Item ID: D205-596-107 Accept *N900040100* Setup Start *NS1*
 Revision ID: URF 14-644 Stop *NS2*
 Item Name: Aft Crosstube - Extended Height 31"
 Start Date: 11/21/2016 Start Qty: 1.00 *1* Cust Item ID:
 Required Date: 11/29/2016 Req'd Qty: 1.00 *1* Customer:
 Reference:

DRAWING NO. D205-596-107	TITLE CROSSTUBE ASS'Y, HI-HI AFT	REV. B	DART AEROSPACE LTD ENGINEERING ORDER		D.E.O. NO. D205-596-107-B-2	SHEET NO. SHEET 1 OF 1	SCALE NTS
DRAWN <i>q</i>	CHECKED <i>A.P.</i>	MFG. APPR. <i>A</i>	APPROVED <i>MD</i>		DE APPR. <i>#</i>		
DATE 13.11.11	DATE 13.11.19	DATE 13.11.19	DATE 13/11/21		DATE 13/11/21

DRAWING NO. D205-596-107	TITLE CROSSTUBE	REV. B	DART AEROSPACE LTD ENGINEERING ORDER		D.E.O. NO. D205-596-107-B-3	SHEET NO. SHEET 1 OF 1	SCALE NTS
DRAWN <i>qp</i>	CHECKED <i>A.P.</i>	MFG. APPR. <i>AA</i>	APPROVED <i>RS</i>		DE APPR. <i>HT</i>		
DATE 15.01.15	DATE 15.01.20	DATE 15.01.20	DATE 15.01.20		DATE 15.01.20

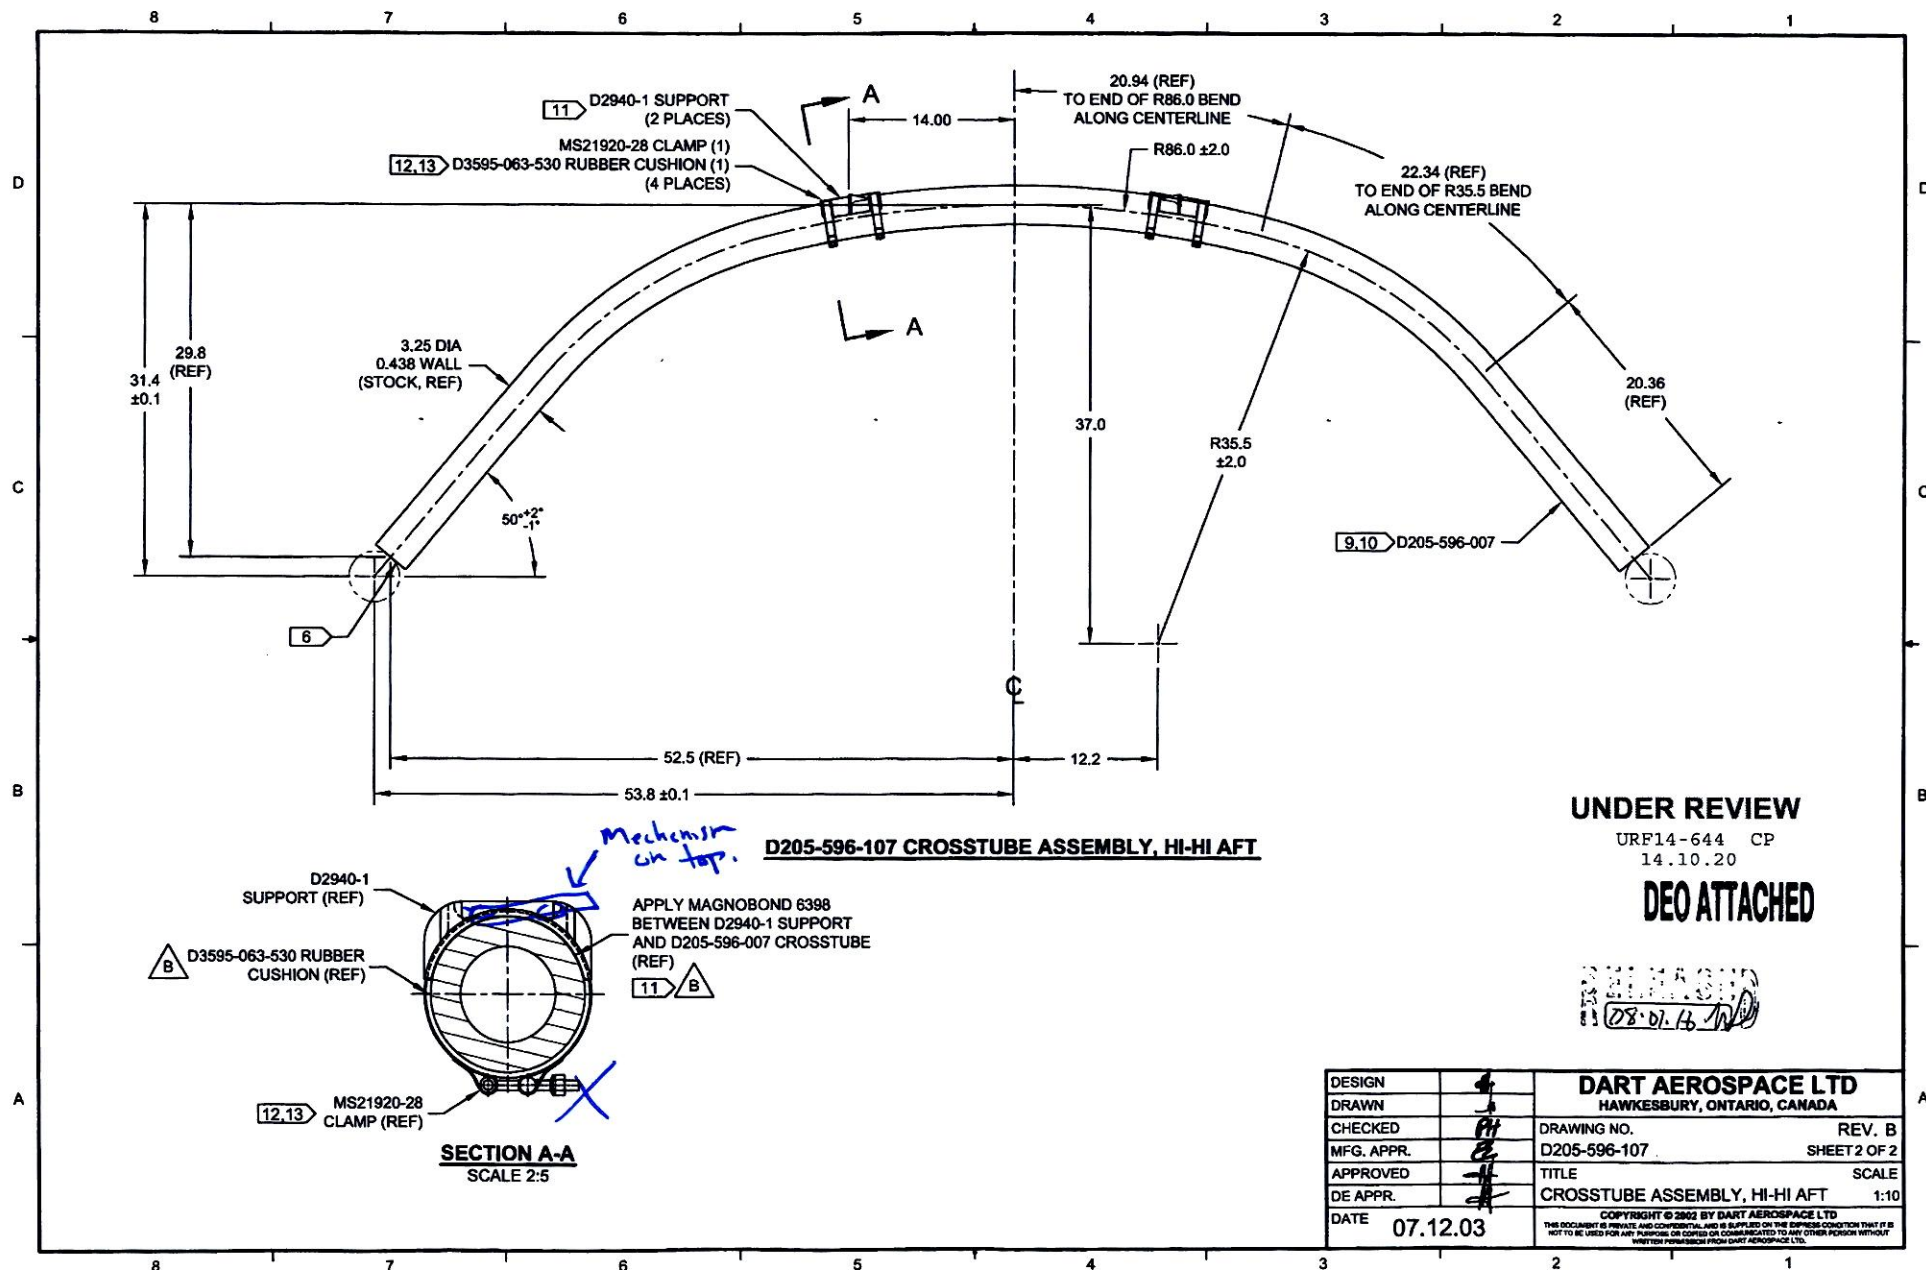
PURPOSE:

REPLACE MAGNOBOND WITH PROSEAL.

CHANGE:

IS:

Qty	Part Number	Description
A/R	PROSEAL 890 B-2	SEALANT, AMS-S-8802 CLASS B-2

WAS:

A/R	MAGNOBOND 6398	ROCKWELL SPECIFICATION RBO-120-023 ADHESIVE (TEXTRON/BELL SPEC. 299-947-100, TYPE II, CLASS 2 ADHESIVE)
-----	----------------	---

NOTE 11 & 13, SHEET 1 IS AMENDED AS FOLLOWS:

IS:

- 11) TO INSTALL D2940-1 SUPPORT: ABRABE MATING SURFACE OF SUPPORT AND CROSSTUBE WITH 180-GRIT SANDPAPER AND REMOVE RESIDUE WITH MEK (OR EQUIVALENT). APPLY A 0.04" TO 0.07" THICK LAYER OF PROSEAL 890 CLASS B-2 (OR AMS-S-8802 CLASS B-2) SEALANT TO MATING SURFACE OF SUPPORT.
- 13) TORQUE CLAMPS 80 TO 100 IN-LB. ENSURE AT LEAST 1.5 THREADS SHOWING IN SAFETY AND THAT NUT HAS NOT BOTTOMED-OUT AFTER TORQUING. **PRIOR TO PACKAGING, RE-CHECK TORQUE ON CLAMPS AFTER PROSEAL 890 SEALANT HAS CURED FOR 72 HOURS.**

WAS:

- 11) APPLY A 0.03" TO 0.06" THICK LAYER OF MAGNOBOND 6398 TO THE SURFACE OF D2940-1 THAT WILL BE IN CONTACT WITH THE CROSSTUBE. LET CURE FOR 12 HOURS AFTER INSTALLATION AND PRIOR TO PACKAGING.
- 13) TORQUE CLAMPS 80 TO 100 IN-LB.

FIGURE 1 - SUPPORT INSTALLATION

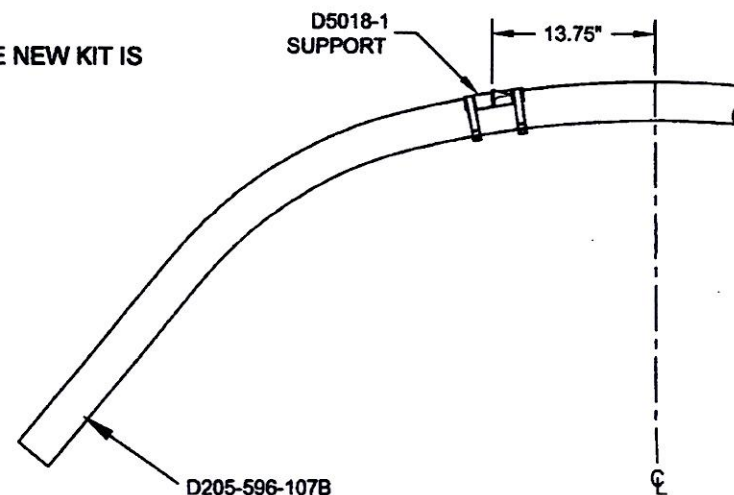
CHANGE:

ADD THE FOLLOWING CROSSTUBE ASSEMBLY:

Qty	Part Number	Description
X	D205-596-107B	CROSSTUBE ASSEMBLY (214 HI-HI AFT)

THE D205-596-107B CROSSTUBE HAS THE SAME PARTS LIST AS THE D205-596-107 CROSSTUBE EXCEPT AS FOLLOWS:

IS:

2	D5018-1	SUPPORT
---	---------	---------

WAS:

2	D2940-1	SUPPORT
---	---------	---------

INSTALL THE SUPPORTS AS SHOWN IN FIGURE 1 OF THIS ENGINEERING ORDER. THE NEW KIT IS OTHERWISE ASSEMBLED PER THE D205-596-107 CROSSTUBE.
